SUBJECT: NORTH CAROLINA STATE UNIVERSITY - AMENDMENT RE: ADMINISTRATIVE  
CHANGES (TAC NO. MA9912)

Amendment No. 14  
License No. R-120

**TECHNICAL SPECIFICATIONS FOR THE  
NORTH CAROLINA STATE UNIVERSITY  
PULSTAR REACTOR**

SAFETY EVALUATION BY THE OFFICE OF NUCLEAR REACTOR REGULATION

Figure 6.1-1

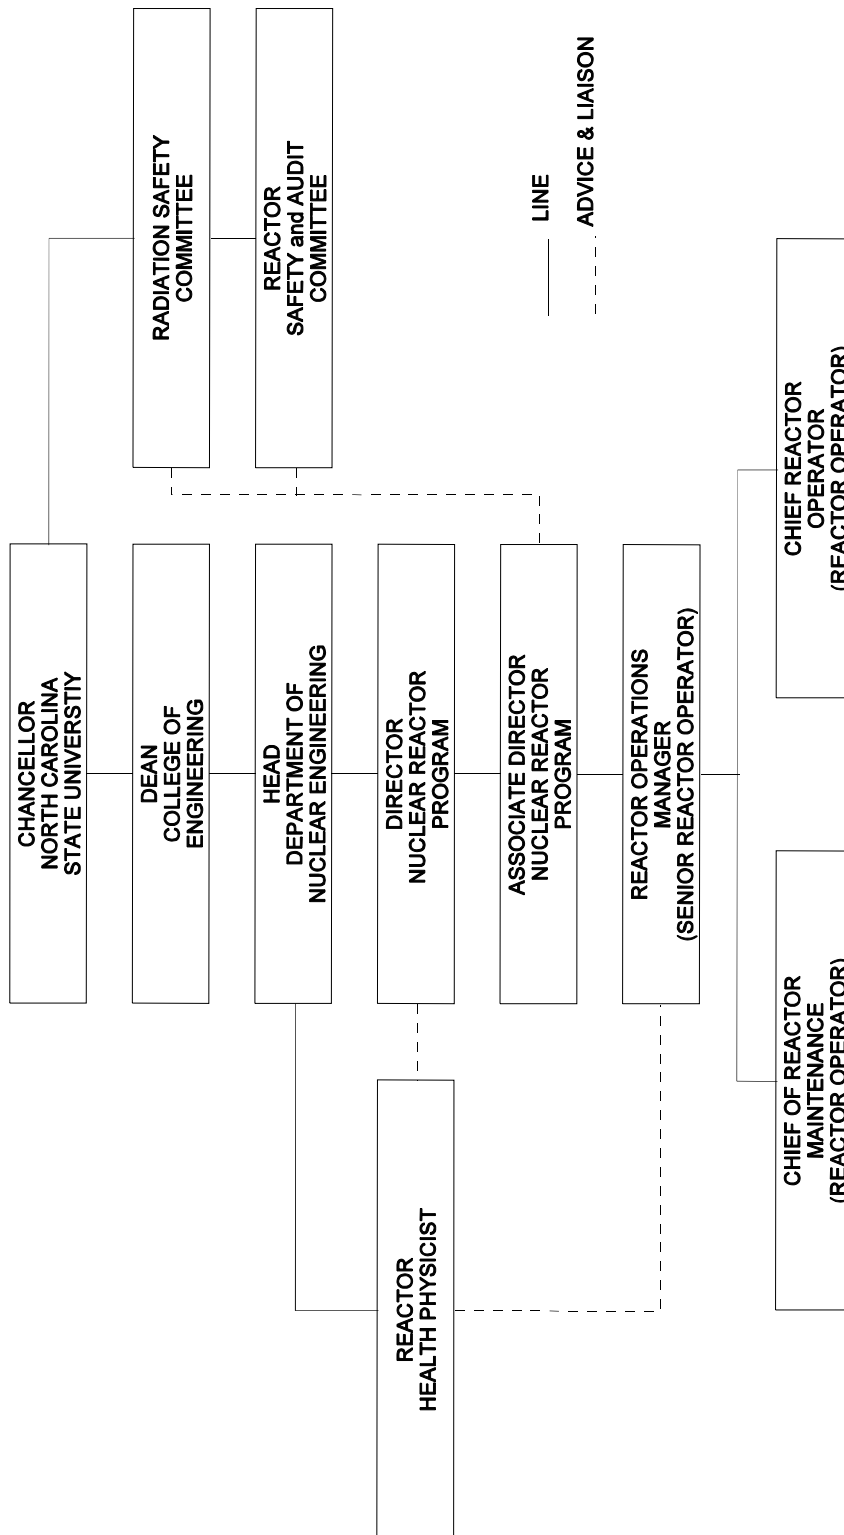
- a. RSC shall consist of at least five members from the general faculty who are actively engaged in teaching/research involving radioactive materials for terms of at least three years, no more than two permanent members from the line organization given in Figure 6.1-1, and at least one permanent member from the Radiation Safety Division of the Environmental Health and Safety Center. Non-faculty members who are knowledgeable in nuclear science or radiation safety fields may also serve as members for terms of at least three years. Requirements for membership and appointments to the committee are made by the University through the office of the Vice Chancellor for Finance and Business and the Provost.

- c. A quorum shall consist of not less than a majority of the full RSC or RSAC and shall include the chairman or his designated alternate. Members from the line organization shown in Figure 6.1-1 shall not form a quorum.
- d. RSC and RSAC shall meet at least four times per year, with intervals between meetings not to exceed six months. Both committees may also meet upon call of the Chair.
